WARWICK SEWER AUTHORITY

**CONTRACT 91A: WARWICK WASTEWATER TREATMENT FACILITY
LEVEE IMPROVEMENTS – PHASE III
WARWICK, RHODE ISLAND
PARE PROJECT 15069.00**

ADDENDUM NO.1

Issued: April 15, 2015

SHEET NO.: 4.0

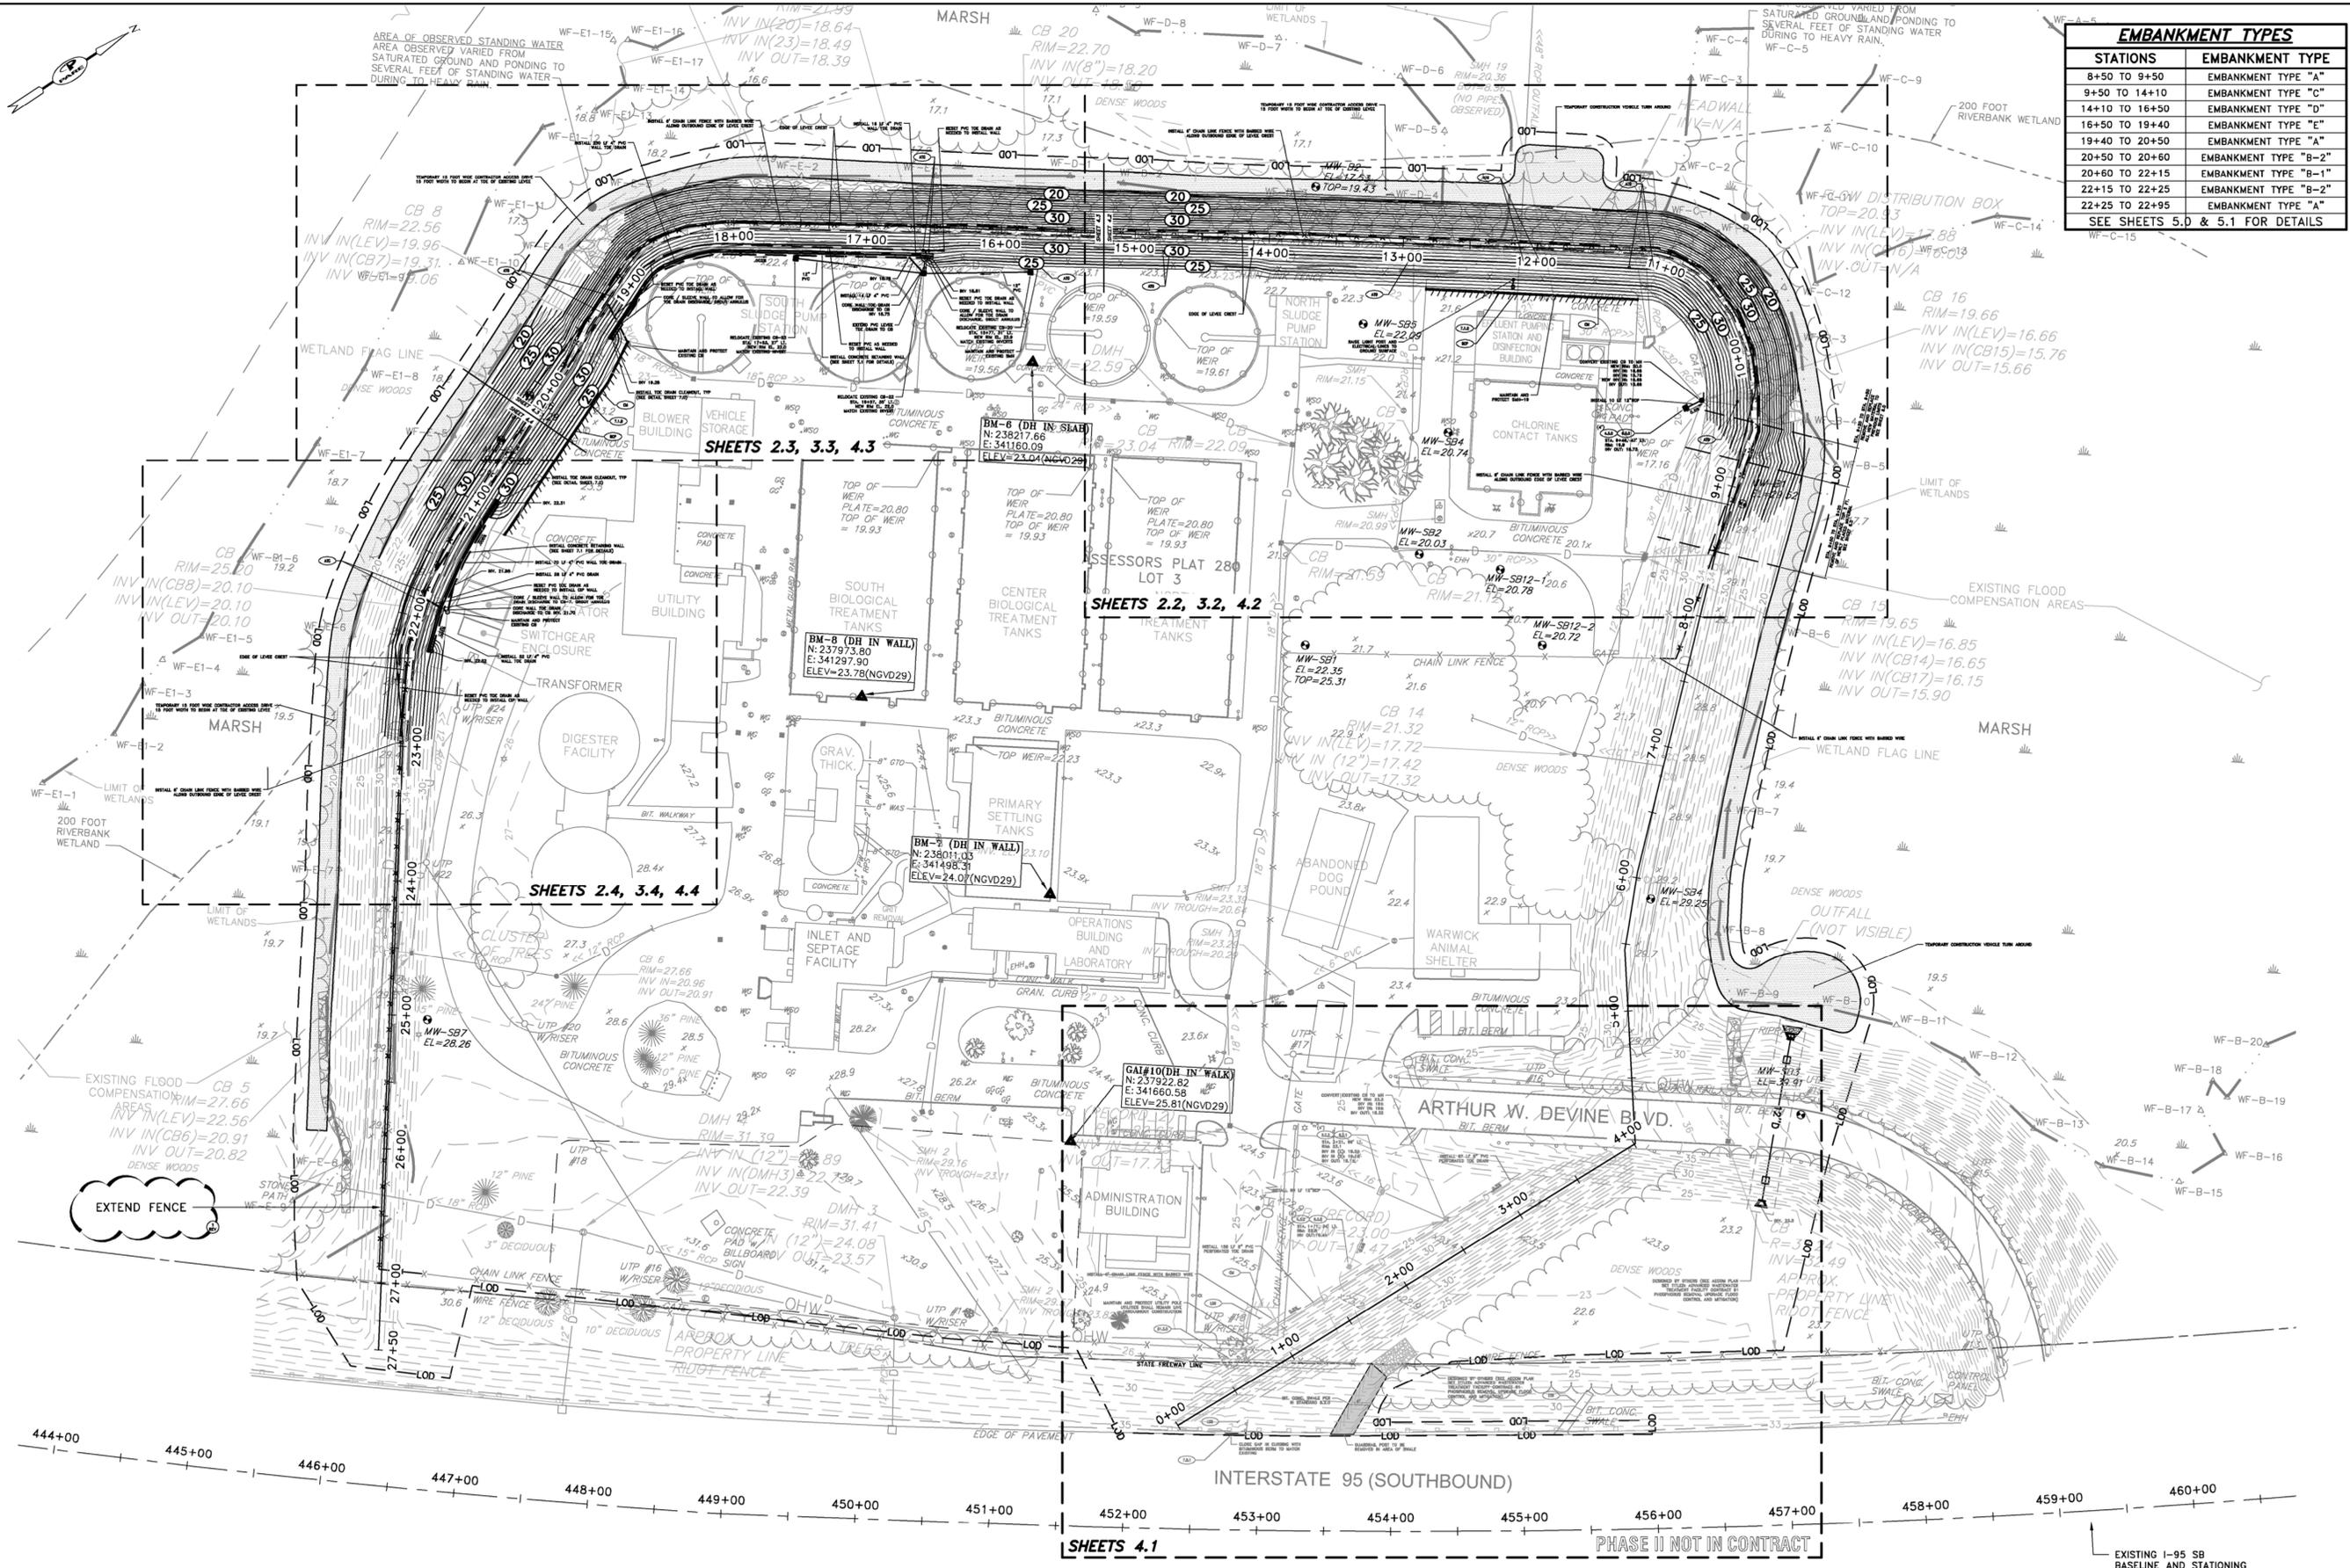
Sheet Nos. 3.0 and 4.0 have been revised to show the extents of the required Erosion and Sediment Controls (Sheet No. 3) and the additional fence that will need to be installed (Sheet No. 4)

- A. *The chain link fence will begin at STA 7+65 as shown on the plan view of Sheet 4.0.*
- Note that the revised drawing No. 4.0 has added a section of fence to extend from STA 23+00 to STA 26+90 where it will then tie into existing perimeter fencing.*

REVISIONS:		
1	04-15-16	EXTEND FENCE
